NOTICE OF DECISION

Newberg SAIL Addition and Parking Modifications – 603 S Meridian Street
Code Adjustment and Design Review – ADJC22-0004 / DR222-0007

Newberg SAIL Addition and Parking Modifications – 603 S Meridian Street
Code Adjustment and Design Review –ADJC22-0004 / DR222-0007
Newberg School District

REQUEST: Addition with setback code adjustment and parking lot modifications.

1 ARCHITECTURAL SITE PLAN
1/8" = 1'-0"

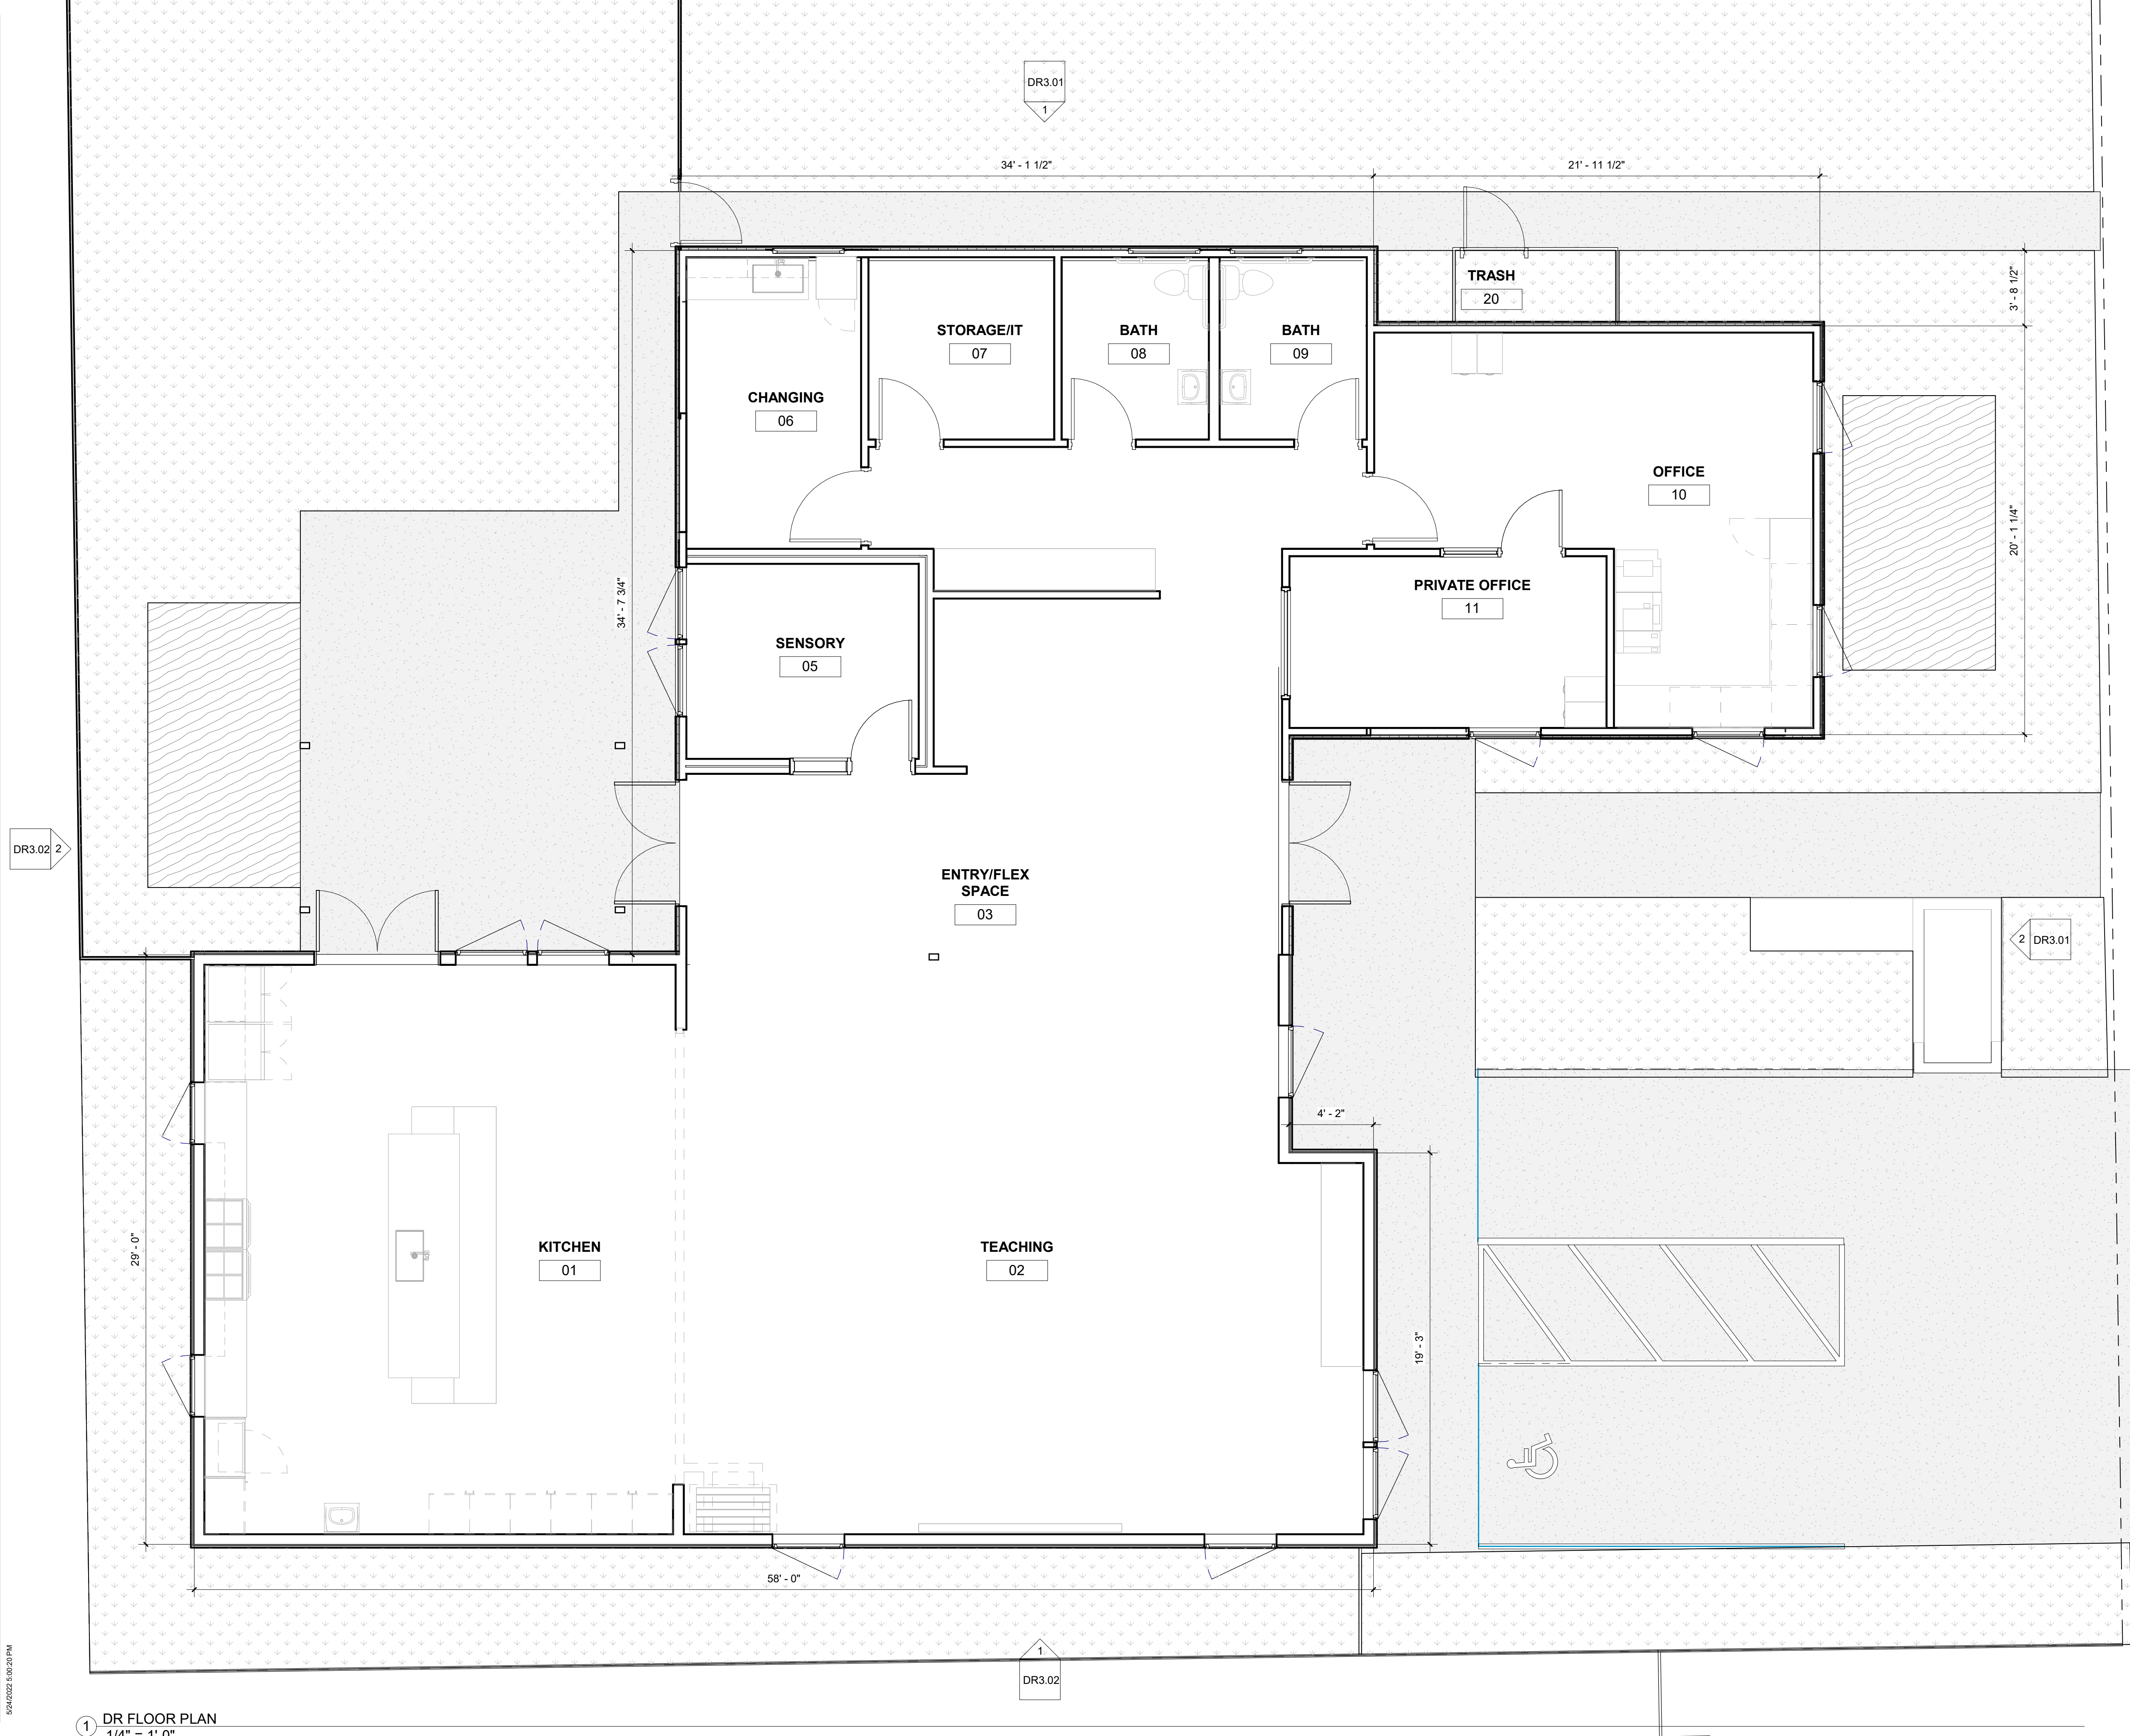
Finding: According to the submitted parking lot plan, there will not be more than three spaces that would require backward movement of a vehicle into a street. The parking lot shows two parking spaces that match the surrounding single family home parking requirements and typical layout. Vehicles will pull in headfirst from S Meridian Street and will then be required to reverse out. The narrative states one space will be ADA van accessible and the other will be used as pull in drop off location. No service driveway is proposed with this parking lot configuration. This criterion is met.

Finding: The submitted site plan shows the two parking spaces will be accessed by pulling head in from S Meridian Street and face the Newberg SAIL Program building. No parking will be located that would allow a vehicle to encroach on abutting private or public properties. However, due to the configuration of the parking and the pedestrian path, staff encourage the applicant to place bumpers in the two parking spaces so that vehicles will not encroach on to the ADA accessible entry path to the building. This criterion is met.

Finding: The applicant's narrative does not address private pathways; however, the site plan shows that a more than four-foot-wide access path is being proposed from the parking area to the main door. There is also a main path that is over five feet wide leading from the sidewalk on S Meridian Street to the main building doors. Both paths meet this sections requirement for pathways to be a minimum of four feet wide. The proposed concrete path that runs parallel to E Sixth Street along the north side of the building is less than four feet wide. A revised site plan showing all private pathways meeting the standard of NMC 15.440.140(B) shall be submitted with building permit application plans to be reviewed and approved prior to issuance. If the aforementioned condition is adhered to this criterion will be met.

Finding: The parking area does show a cross hatching in the area between the two proposed parking spaces. If painted striping is used for crosswalk areas in a service drive, it should consist of thermoplastic striping or similar type of durable application. If the aforementioned condition is adhered to this criterion will be met.

Finding: The site is located at the intersection of two streets, S Meridian Street and E Sixth Street. Per the submitted site plan, it appears that no objects will be located within the 50-foot vision clearance triangle of the two intersecting streets. The site has a driveway approach from S Meridian Street requiring a 25-foot vision clearance triangle. The submitted site plan shows that a planter box that will double as a sign is located within that 25-foot vision clearance triangle. The narrative states that the sign will be 3 feet tall. Per 15.410.060 (C) the vision clearance triangle shall be kept free of all visual obstructions between the heights of two and one-half feet to nine feet. Therefore, the sign would need to be relocated outside of the driveways vision clearance triangle or reduced in height. At time of building permit application, the applicant shall include a site plan showing that no items between the heights of two and one-half feet and nine

② DR ELEVATION - EAST
1/4" = 1'-0"

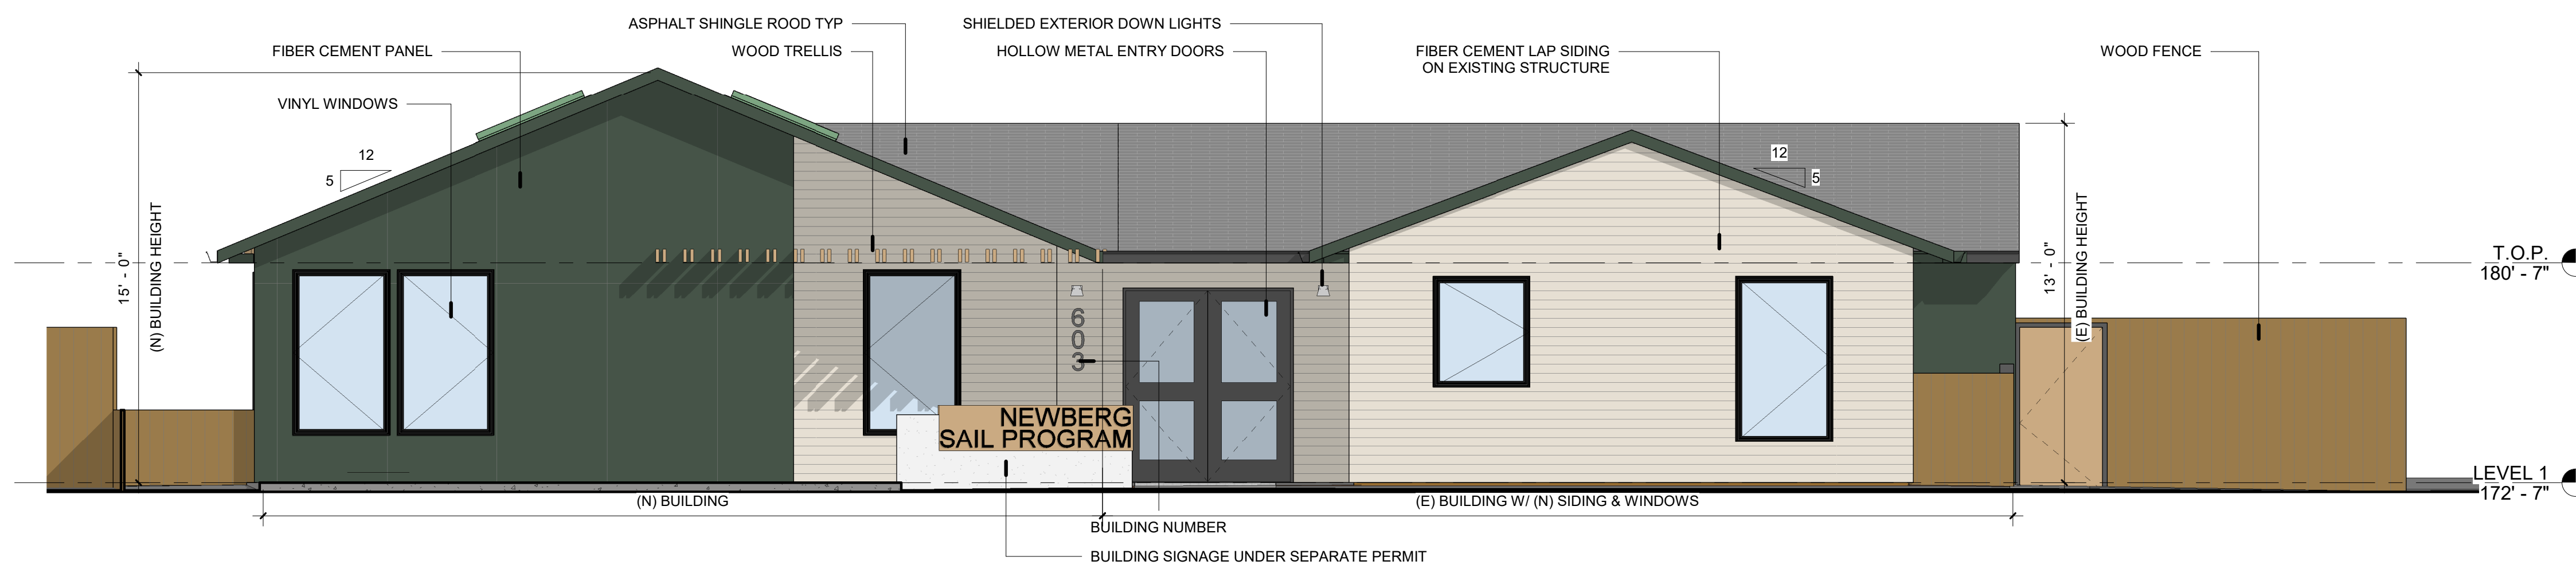
Finding: Lighting information was not provided with application, however on the east elevation drawing, sheet DR3.01, two exterior lights are noted on the front of the building, and two on the north elevation. Analyzing the site plan there is a new ADA pathway that is being developed from the front door to the south property line where parking will be. If photometrics allow, staff recommend placing an additional light along the southern portion of the ADA path to allow for safe pedestrian travel during winter months. The applicant will need to provide a photometric plan showing that exterior lighting will not exceed one-half-foot candle at the property line as well as manufacture cut sheets for all exterior lighting. This is to be submitted with building permit plans and approved prior to building permit issuance. If the aforementioned condition is adhered to, these criteria will be met.
